Village of Cassopolis

CWSRF Interceptor Force Main Replacement

ADDENDUM 1

June 12, 2026

Sheet SA-1.1 – Sanitary Manhole Replacement Plans

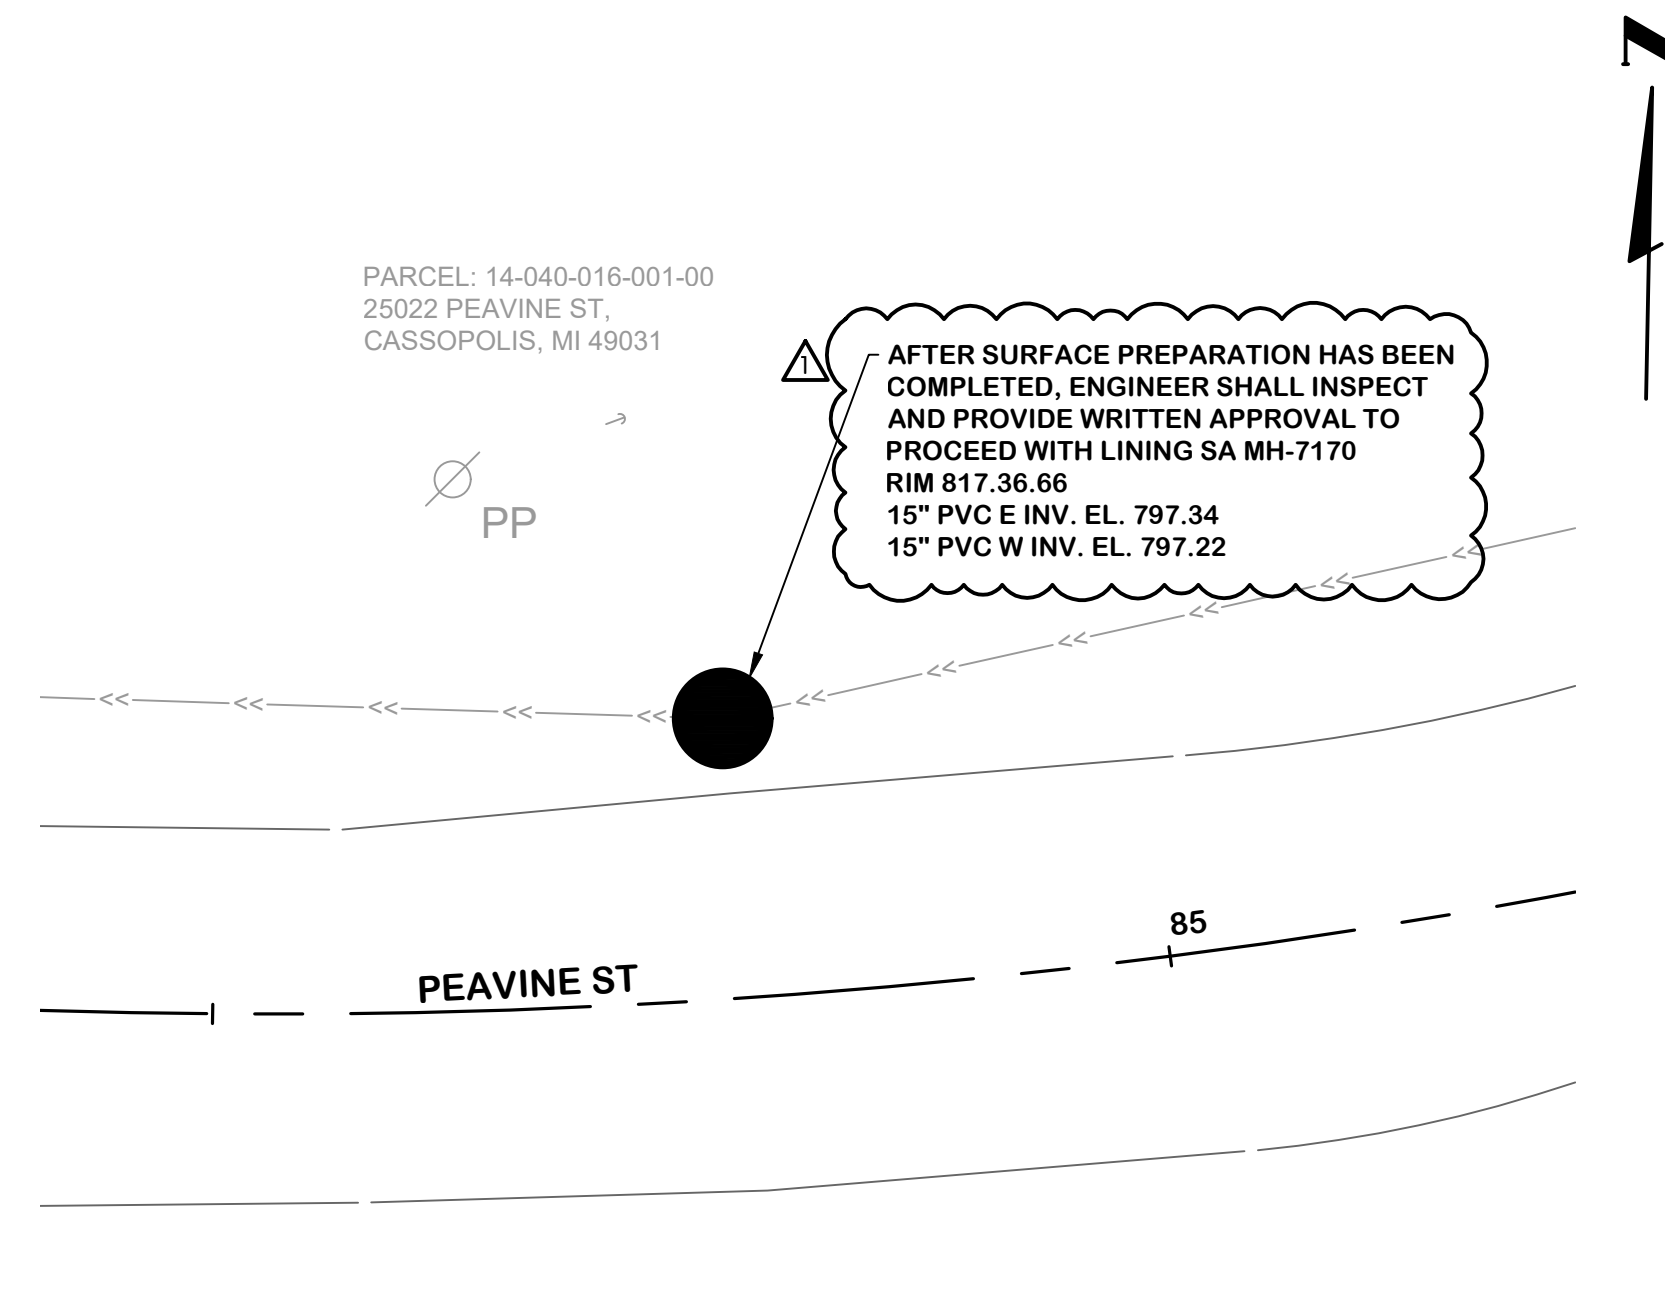
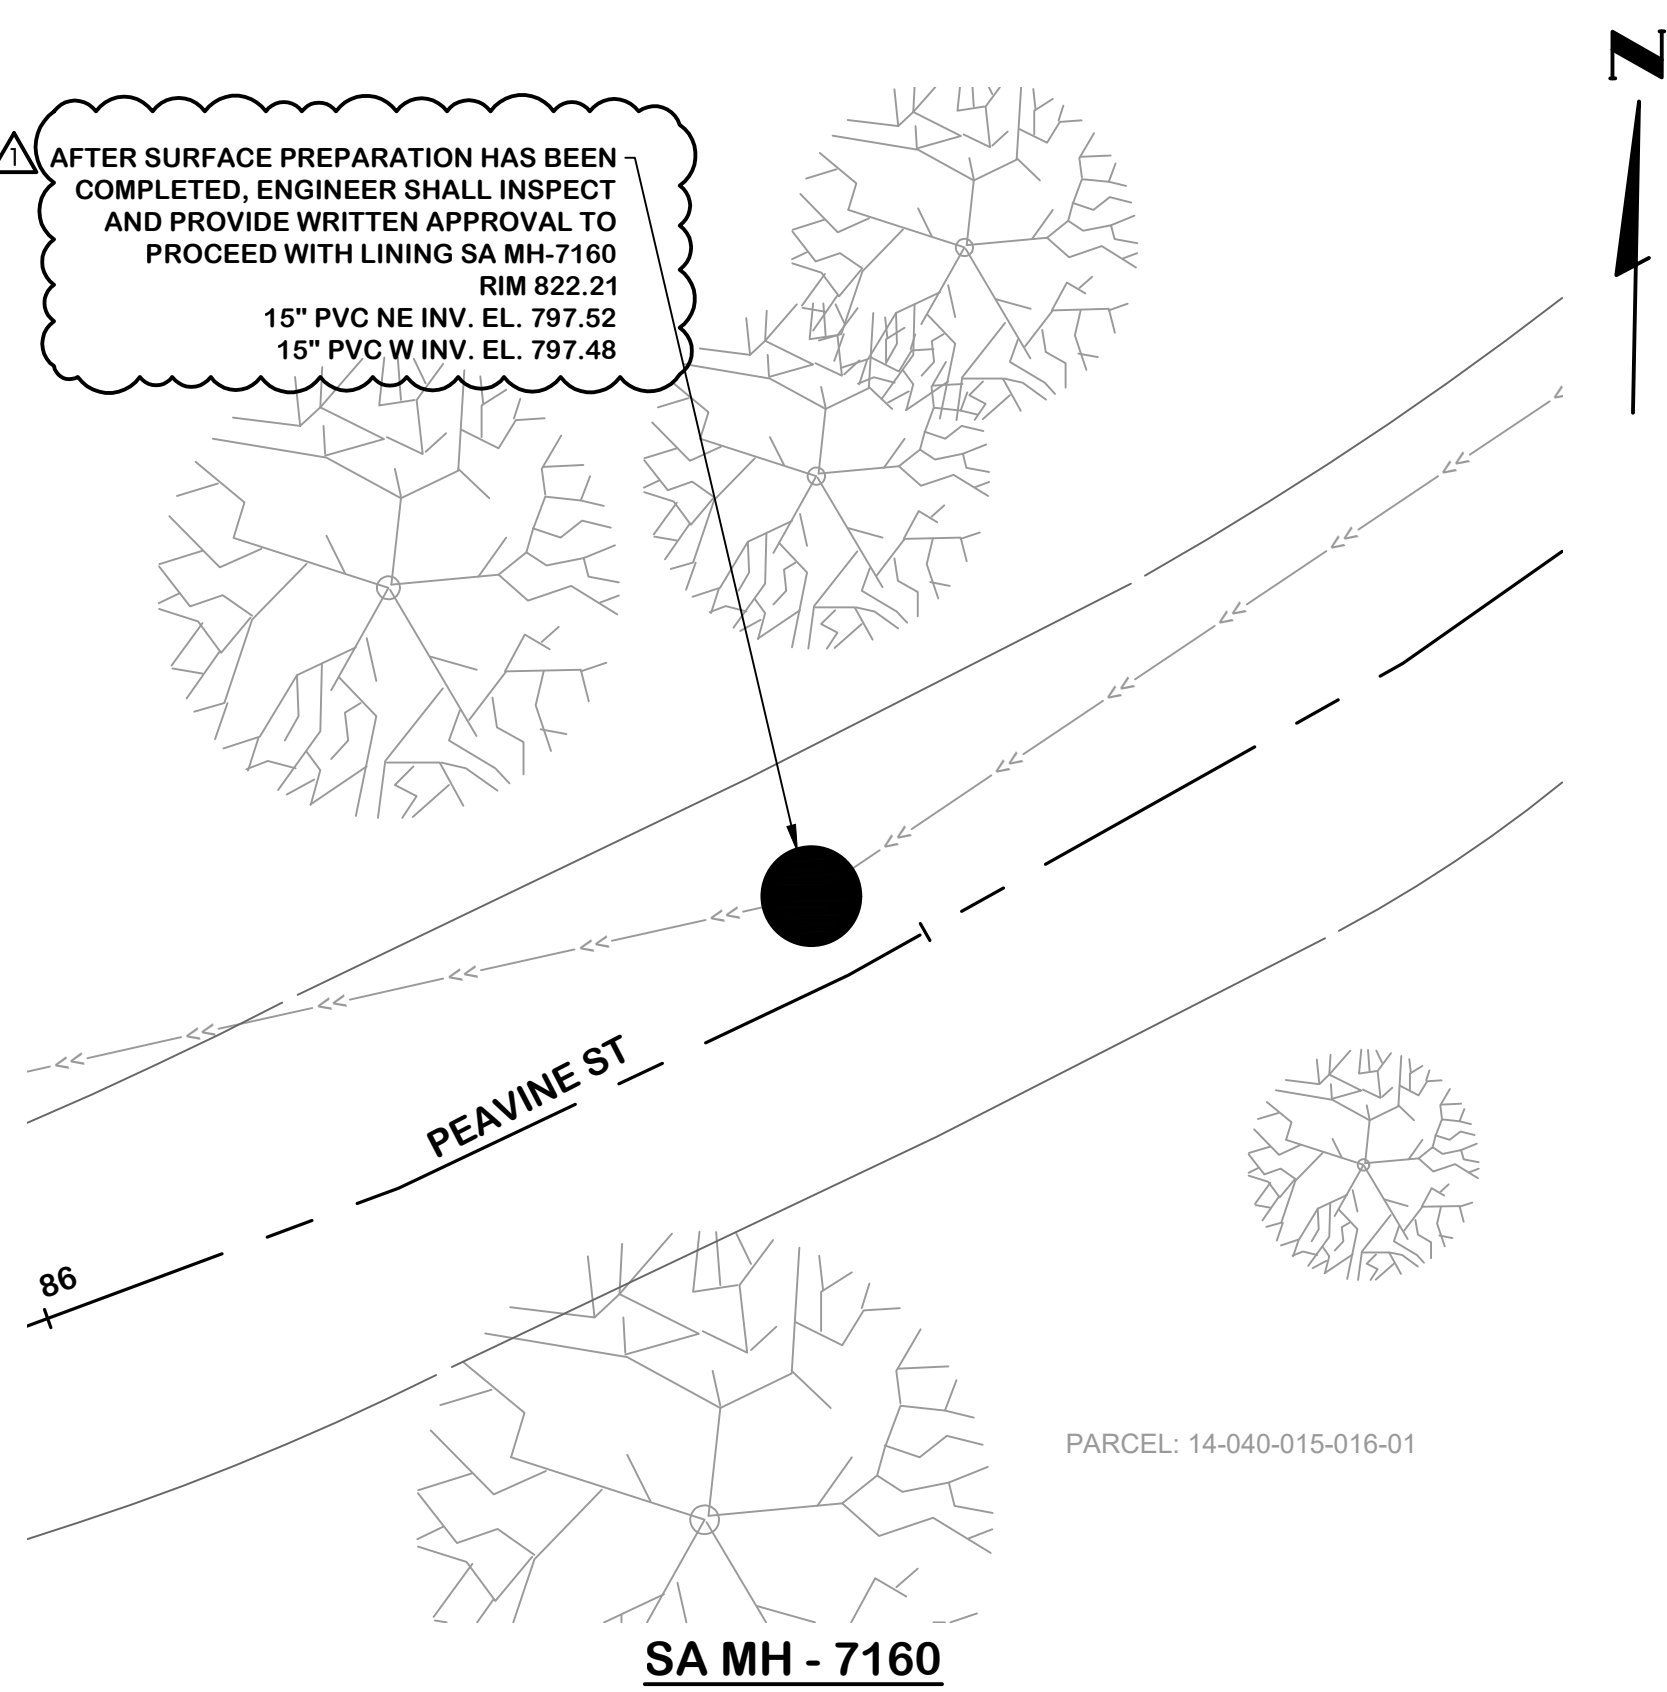
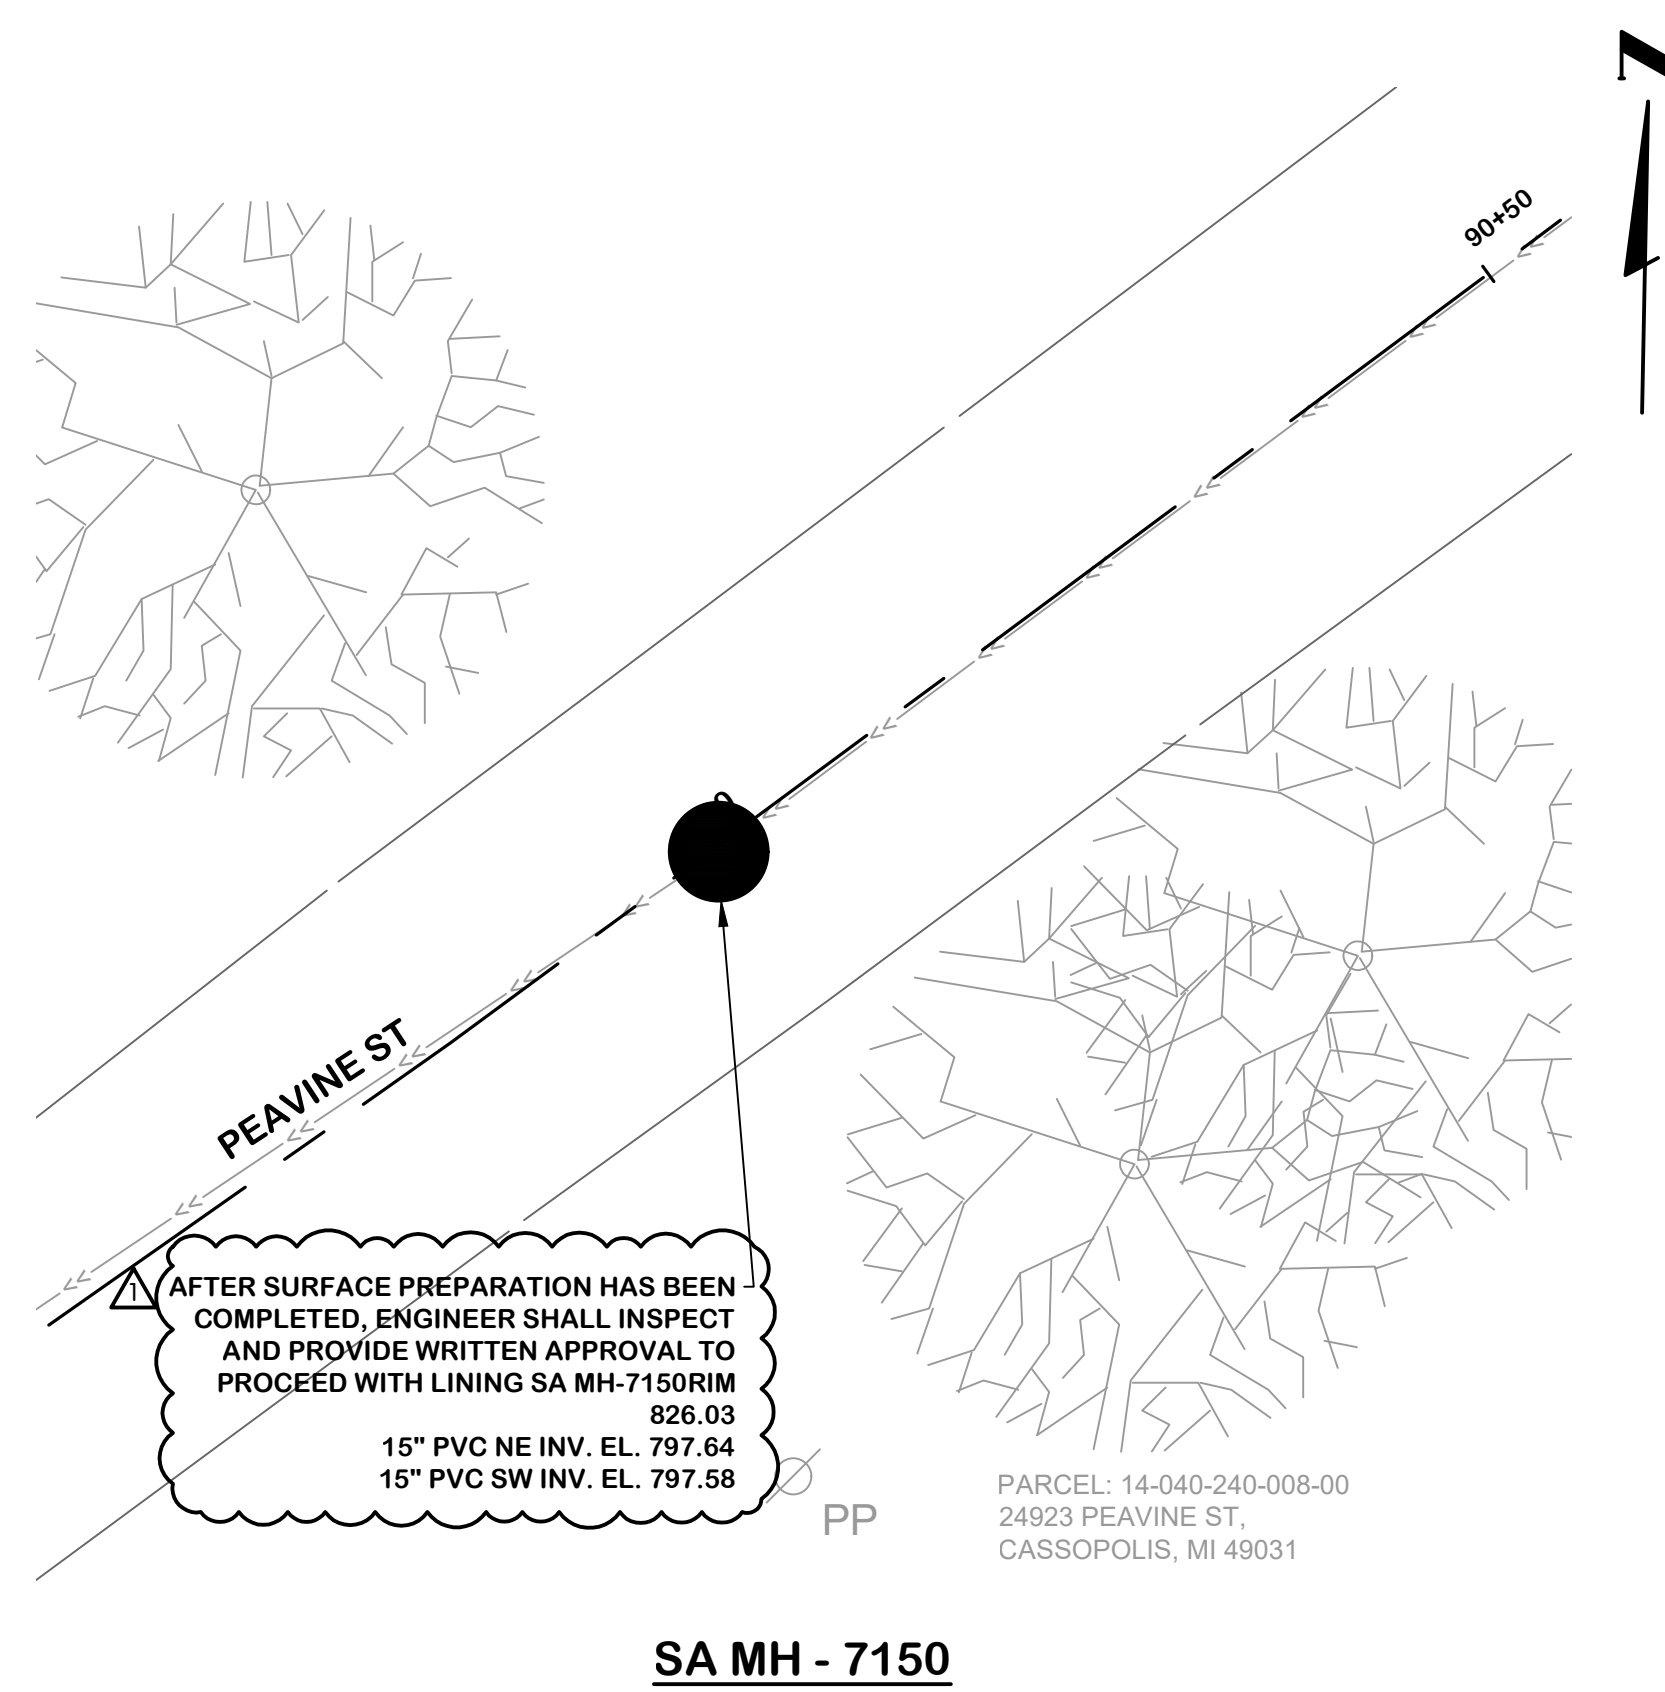
SA MH-7170, SA MH-7160, SA MH-7150, and SA MH-7140 were removed, and an additional note was added to this sheet. Replace the sheet with the provided Sheet SA-1.1 included with Addendum 1.
